AIRPORT FUEL FARM

Construction Change Order

For required changes to the relocation of George Haddaway Drive

05-02 Bulk Fuel Storage and Dispensing System

DT-1

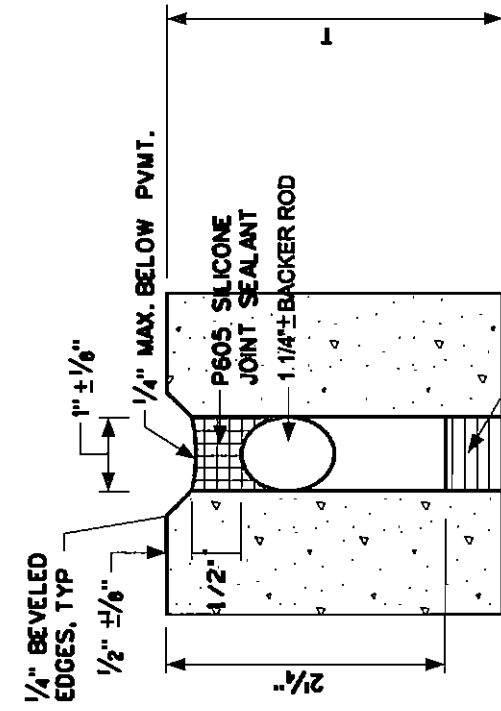
MODIFICATIONS TO THE PLANS

There have been modifications to the following plan sheets

1. DT1 – detail sheet 1
2. DT2 – detail sheet 2

SCARIFY 6" DEPTH AND RECOMPACT TO 95% STANDARD PROCTOR DENSITY. SUBSIDIARY TO 10" REINFORCED CONCRETE PAY ITEM.

DATE: OCTOBER 25, 1974
 SHEET 9 OF 33

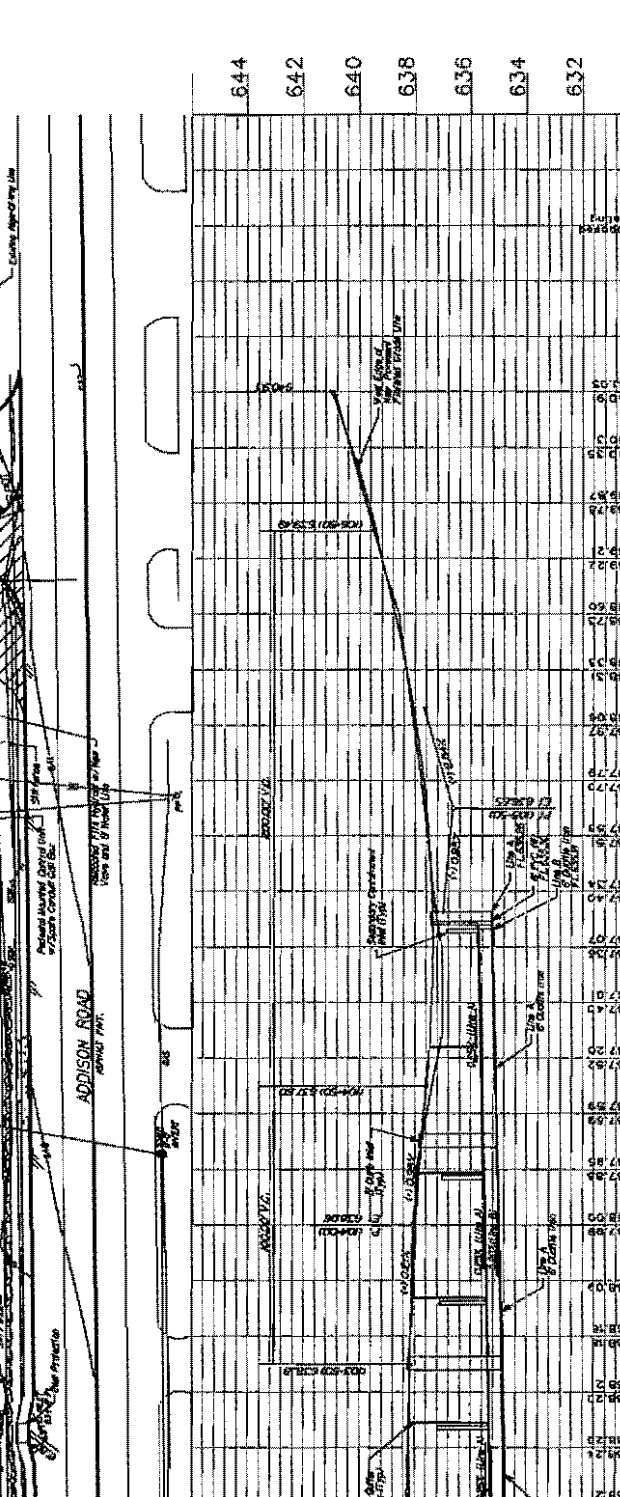
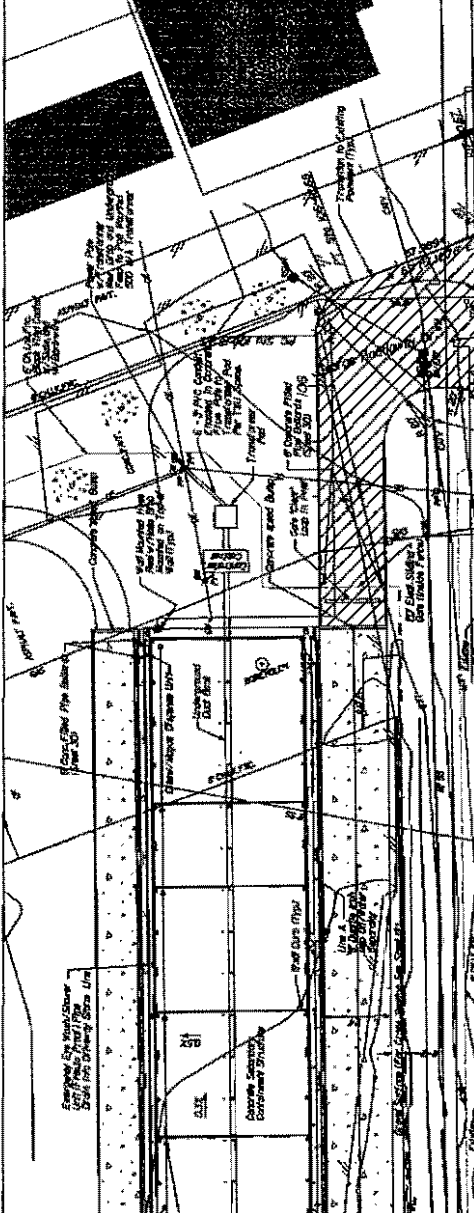
1. Sheet 9, Note #5, Delete comment, there is no emergency generator, only an emergency generator cable connection and disconnect switch
2. Sheet 9, Note #3, Replace comment with the following:
Disconnect fire hydrant after gate valve, install a 45-degree elbow and extend fire hydrant line to new location. Install thrust blocks at elbow and new hydrant location and use a 1" tap and sleeve on new hydrant line for new water service to facility.
3. Specification Section 13201- Fuel Storage Tank Packages, Part 2, Paragraph 2.02, J. Tank Accessories, Item 2. (page 209), should read: Provide suction nozzle with a floating suction assembly (4-inch for Jet A, 3-inch for AvGas).
4. New sheet 9 attached.
5. Appendix A – Equipment List will be available upon request.
